# United States Patent and Trademark Office

APPLICATION NO.	FILING DATE	FIRST NAMED INVENTOR	ATTORNEY DOCKET NO.	CONFIRMATION NO.
10/664,982	4,982 09/17/2003 David Chong		112055-0040P1	4640
24267	7590 09/06/2006		EXAMINER	
CESARI AND MCKENNA, LLP			ANDUJAR, LEONARDO	
88 BLACK FALCON AVENUE BOSTON, MA 02210			ART UNIT	PAPER NUMBER
2001011, 111			2826	2826
			DATE MAILED: 09/06/2006	5

#### **DETAILED ACTION**

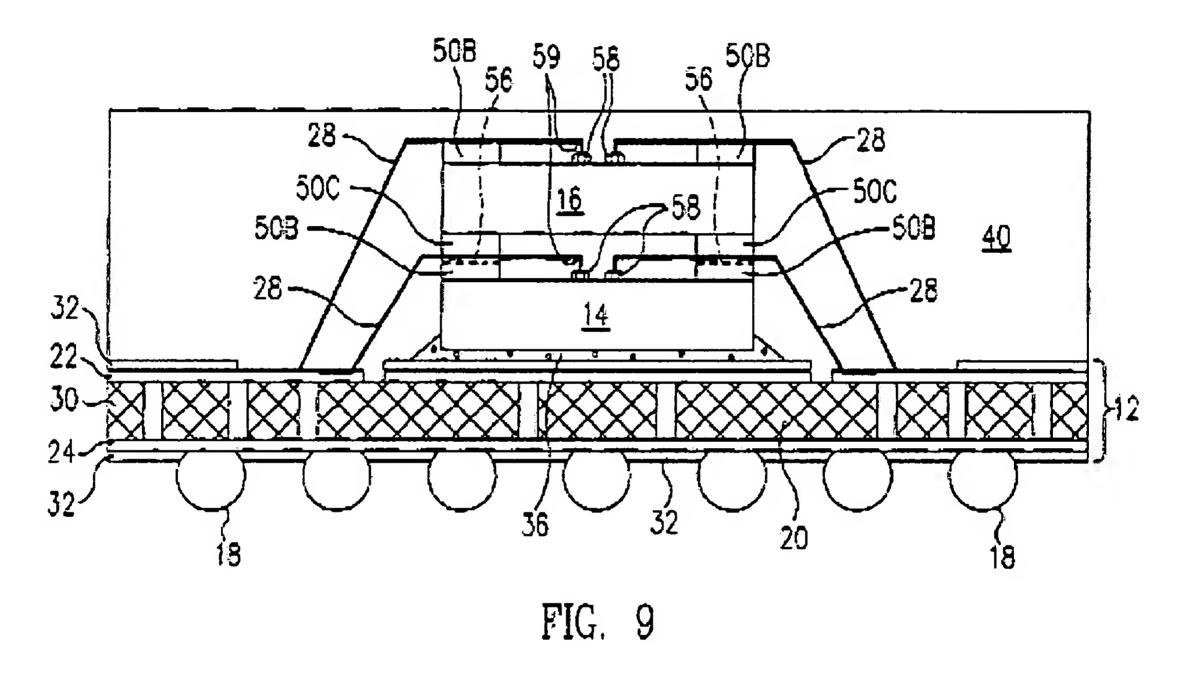
- 5. Regarding claim 1 Shim (e.g. fig. 9) shows a die containing package comprising: a die 14 defining electrical die contacts, a substrate defining first substrate contacts, flattened electrical conductive balls 58 attached to the die contacts and making electrical connections thereto, electrical conductive runs 22/24 on the substrate 12 connecting the first substrate contacts (i.e. the electrical contacts formed by the runs

and the wires 28) to second substrate contacts 18 wherein the second substrate contacts are located on the substrate opposite the first substrate contacts, electrically conductive wires 28 with a first ends making electrical connection to the first substrate contacts, and wherein the other ends are arranged making electrical connections to the flattened electrical conductive balls attached to the die contacts..

- 6. Regarding claim 4, Shim shows that the second substrate contacts are located to accommodate a pin out different from the die.
- 7. Regarding claim 5, Shim (e.g. fig. 9) shows process for packaging a die comprising the steps of: defining electrical die contacts, defining a substrate 12 with first substrate contacts, flattening an electrical conductive balls 58, attaching the flattened electrically conductive balls to the die contacts, forming electrical conductive runs 22/24 on the substrate 12 connecting the first substrate contacts (i.e. the electrical contacts formed by the runs and the wires 28) to second substrate contacts 18 wherein the second substrate contacts are located on the substrate opposite the first substrate contacts, connecting electrically conductive wires 28 to the first substrate contacts,

running the electrically conductive wires substantially parallel to the surface of the die contacts and attaching the other ends of the wires to the flattened electrically conductive balls thereby making electrical connections therebetween and wherein the other ends remain substantially parallel to the surface of the die. Shim does not teach that other ends are horizontally attached to the flattened ball. Nevertheless, Kang (e.g. fig. 3) shows electrically conductive wires 38 that run substantially parallel to the surface of the die and have ends that are horizontally attached to flattened balls 37. According to Kang, this type of connection minimizes a space between the first chip and a second chip, thereby reducing the total height of the semiconductor stack (abstract). It would have been obvious to one of ordinary skill in the art at the time the invention was made to horizontally attach the other ends of the wires disclosed by Shim to the fattened balls in accordance to Kang's invention to minimize the space between the first and the second chip, thereby reducing the total height of the semiconductor stack.

- Applicant's arguments filed 06/20/2006 have been fully considered but they are 9. not persuasive.
- 10. Applicant argues that the prior art does not show that the second contacts are located on the substrate opposite the first substrate contact. Nevertheless, Shim clearly shows this limitation because the first contacts are located on the top surface whereas the second contacts are located on the opposite second surface or bottom surface.

Also, Shim shows that the runs 22/24 are formed on opposite sides of the substrate. As shown in figure 9, the second substrate contacts are located to accommodate a pin out 18 different from the die Note that this pin is different and structurally independent from the die.

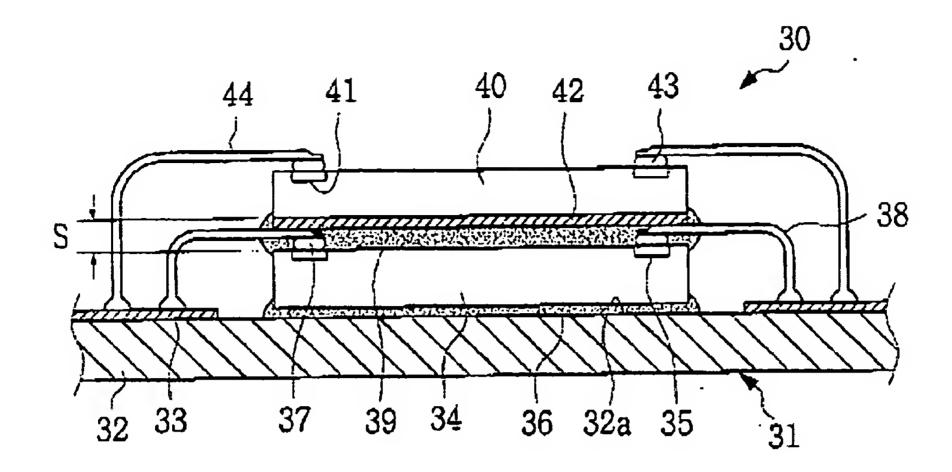
Shim does not teach that other ends are horizontally attached to the flattened ball. Nevertheless, Kang (e.g. fig. 3) shows electrically conductive wires 38 that run substantially parallel to the surface of the die and have ends that are horizontally attached to flattened balls 37. According to Kang, this type of connection minimizes a space between the first chip and a second chip, thereby reducing the total height of the semiconductor stack (abstract).

It would have been obvious to one of ordinary skill in the art at the time the invention was made to horizontally attach the other ends of the wires disclosed by Shim to the fattened balls in accordance to Kang's invention to minimize the space between the first and the second chip, thereby reducing the total height of the semiconductor stack.
